REMARKS

Application No.: 09/893,619

Docket No.: M4065.0467/P467

FIG. 11

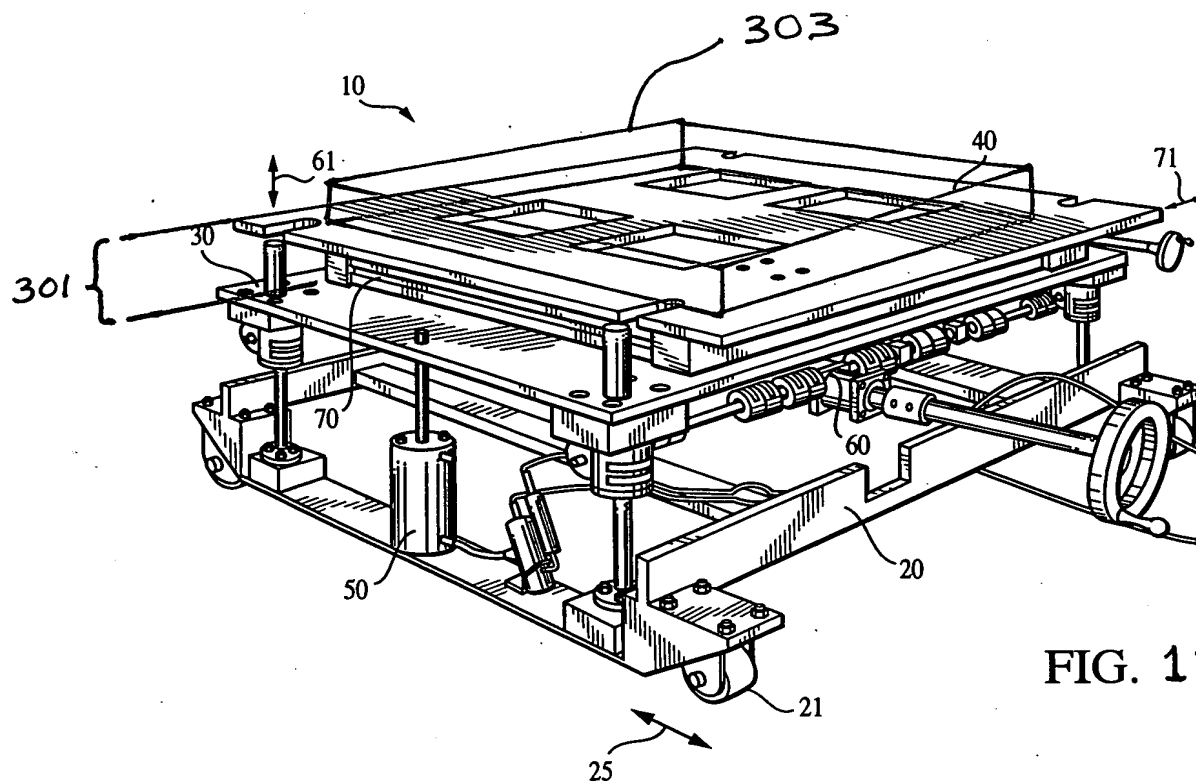
The drawings are objected to under 37 CFR 1.83(a), because they must show the “second slide mechanism and the fo[u]rth section.” The Office Action states that a proposed drawing correction is required. As requested, Applicants are submitting herewith an Annotated Drawing Sheet containing a proposed new Figure 11. The new Figure 11 is a copy of Figure 1 of the as-filed specification, with added markings showing that the combination of a slide mechanism 70 and top plate 40 is represented by numeral 301, and shows a block 303¹ that represents a second slide mechanism and another top plate (or “fourth section” of claim 12). The additions to original Figure 1 are shown in red ink. The specification has been amended to explain the addition of Figure 11. No new matter has been added, as the new markings merely illustrate what is clearly described on page 10, lines 1-10, of the as-filed specification. After new Figure 11 is deemed acceptable, Applicants will submit a formal version of the Figure.
